REQUEST

Current Zoning: MUDD(CD) (mixed use development, conditional)
Proposed Zoning: MUDD(CD) SPA (mixed use development, conditional, site plan amendment)

Approximately 0.43 acres located on the west side of Park Road and north side of Drexel Place.

The petition proposes to modify an approved plan to allow any office or retail use allowed in the MUDD zoning district. The site is currently developed with an office building and a single-family home.

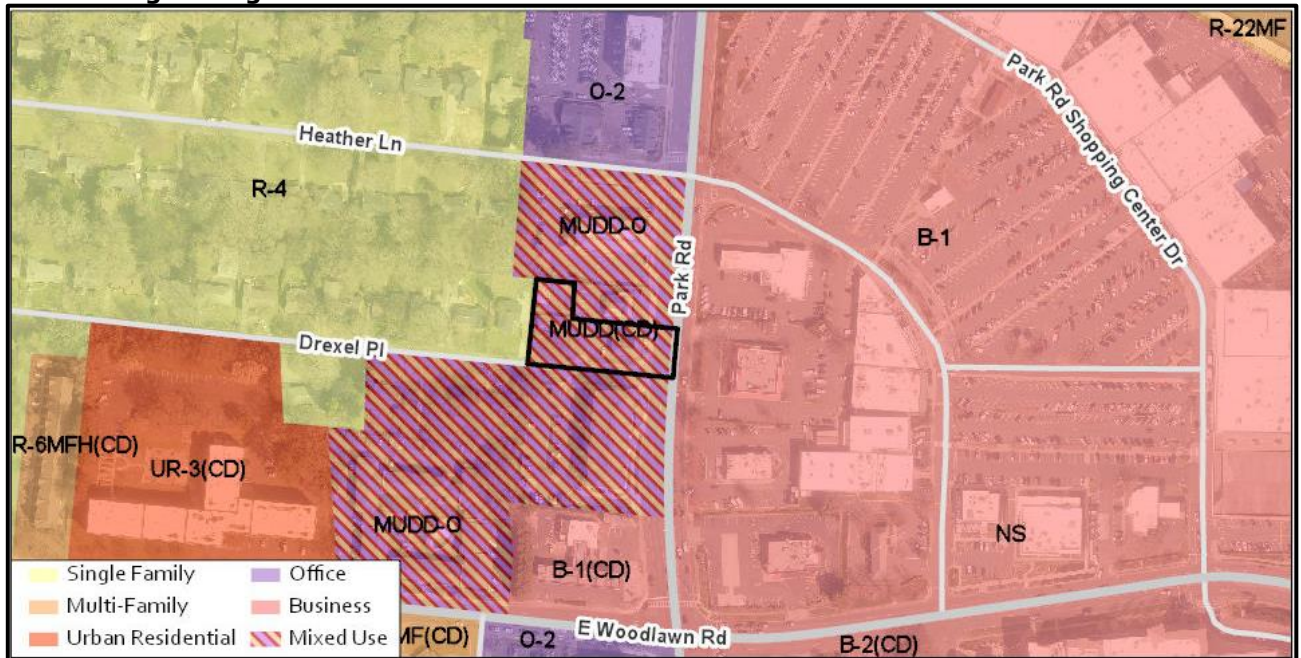
The site plan amendment contains the following changes:

- Reduces the project acreage from 1.77 acres to 0.43 acres.
- Reduces the number of principal buildings from 2 to 1.
- Reduces the building area from 38,000 square feet to 3,200 square feet.

- Limits building height to 40 feet.
- Identifies office and retail uses as permitted uses.
- Provides a 10-foot Class C buffer along the west property line abutting existing single family residential.

- Proposes the following transportation improvements:
 - Proposes one driveway connection to Drexel Place and an internal connection to the property to the north.

- Provides a 6-foot sidewalk and an 8-foot planting strip along Drexel Place, and an 8-foot sidewalk and 8-foot planting strip along Park Road. *Identifies streetscape improvements in development notes on site plan.*

- Illustrates future right of way along Park Road, 40 feet from existing center line. *Adds note specifying that petitioner will dedicate or convey the fee simple interest for 40 feet of right-of-way measured from the centerline of Park Road.*

- Illustrates location of 5-foot wide CATS waiting pad along Park Road.
 - Notes all transportation improvements will be constructed prior to the issuance of the first certificate of occupancy on the site.
